Detailed Site Plan Type 2 Tree Conservation Plan Swann Crossing

DSP-23019
TCP2-036-2024

SUBJECT: Detailed Site Plan DSP-23019
Type 2 Tree Conservation Plan TCP2-036-2024
Swann Crossing

SITE PLAN

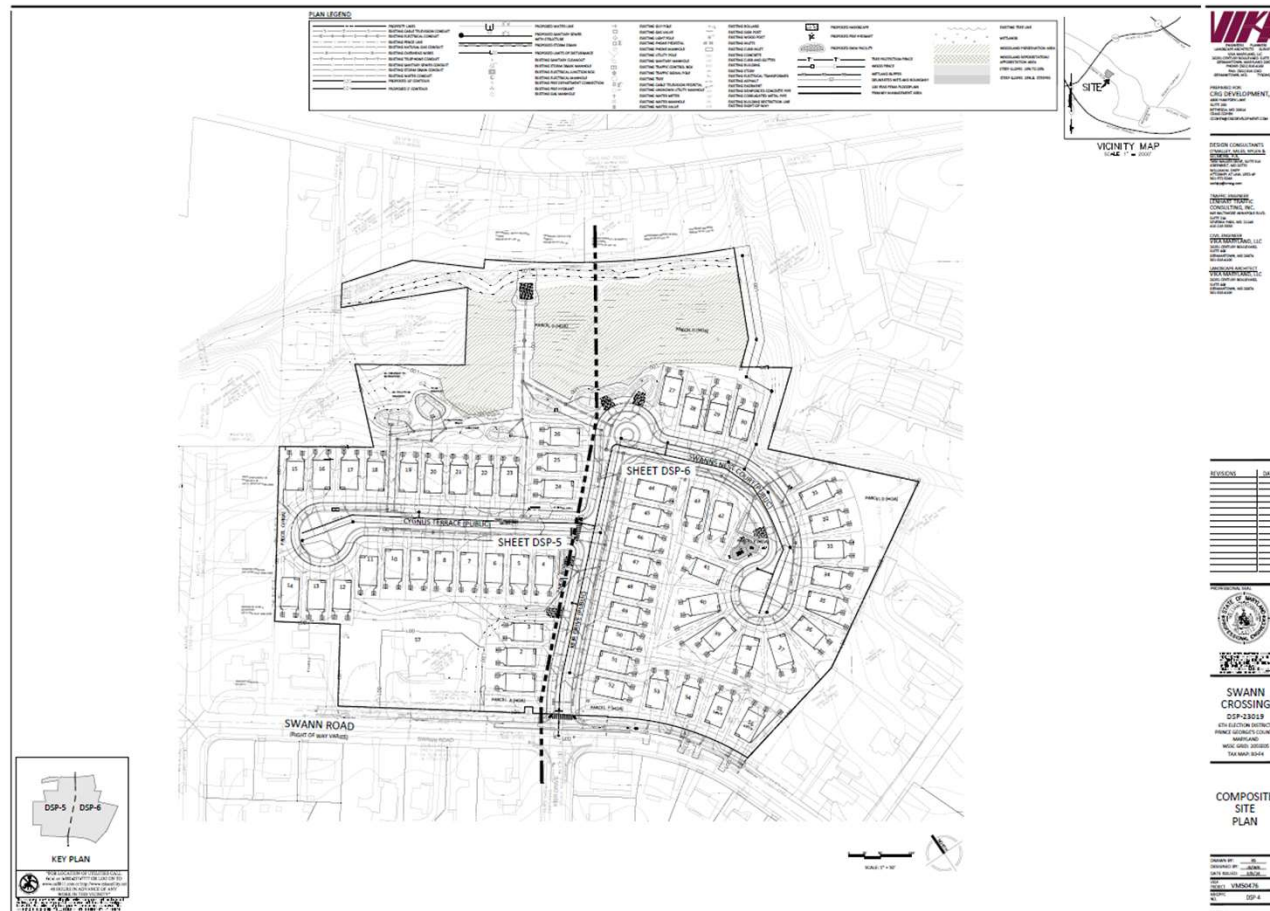
Three bike racks are shown at the recreation area. However, these racks are not labeled, and no detail is provided. A condition is recommended to label the bike racks and provide a detail for inverted-U shaped racks.

Signage: Two entrance, monument signs, are shown on the plans. The 5-foot-high by 2-foot, 6-inch square entrance features will have stone veneer and a precast concrete cap, with an 18-inch-wide by 16-inch-high sign plate. A condition has been recommended to dimension the distance of the monument signs from the right-of-way (ROW).

- a. Label the three bike racks and provide a detail for an inverted U-style or similar model that provides two points of contact for a parked bicycle.

- b. Provide at least one bench and one trash receptacle along Swanns Nest Court.
 - c. Provide at least two dog waste stations throughout the development.

- d. Label the 6-foot-high wood fence on the plan.
 - e. Provide at least one additional inclusive piece of equipment in the recreation area.
 - f. Dimension the distance of the monument signs from the right-of-way.

- g. On sheet DSP-5, delete the "Open Space / Outdoor Recreation Facilities" note in the Woodland Preservation area.
 - h. Show a minimum dedication of 30 feet from the centerline of Swann Road. Label the area of public right-of-way dedication along Swann Road and show the new property line following the right-of-way dedication with its bearings and distances labeled.
